# UNITED STATES DEPARTMENT OF THE INTERIOR BUREAU OF LAND MANAGEMENT

RESENDENT NOTICES AND REPORTS ON WELLS not use this form for proposals to drill or to re-enter an abandoned well. Use Form 3160-3 (APD) for such proposals.

4. Location of Well (Footage, Sec,	T., R., M., or Survey Description)					
UL. M SEC. 6 22S 37E 330' F	FSL & 610' FWL			11. County or Parish, State		
				Lea NM.

## Permanent Abandonment of Federal Wells Conditions of Approval

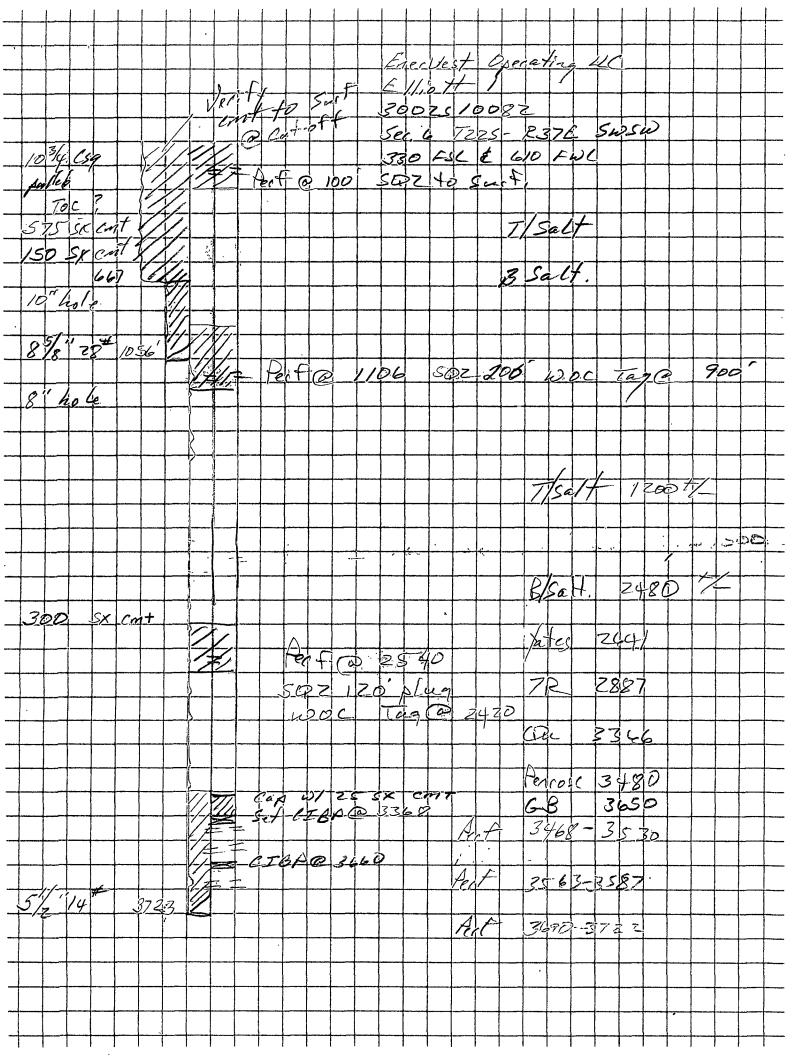
3. Perf. at 1106' Sqz. 100 s 4 Perf. at 100' ciculate 25	tbg. to 3368' circulate hole mu. Cmt. TOC. 1500' WOC & Tsx. Cmt. TOC. 900' WOC & Tsx. Cmt. to surface.	Tag.		e all annulus.

Accepted as to plugging of the well bore. Liability under bond is retained until Surface restoration is completed.

SEE ATTACHED FOR CONDITIONS OF APPROVAL
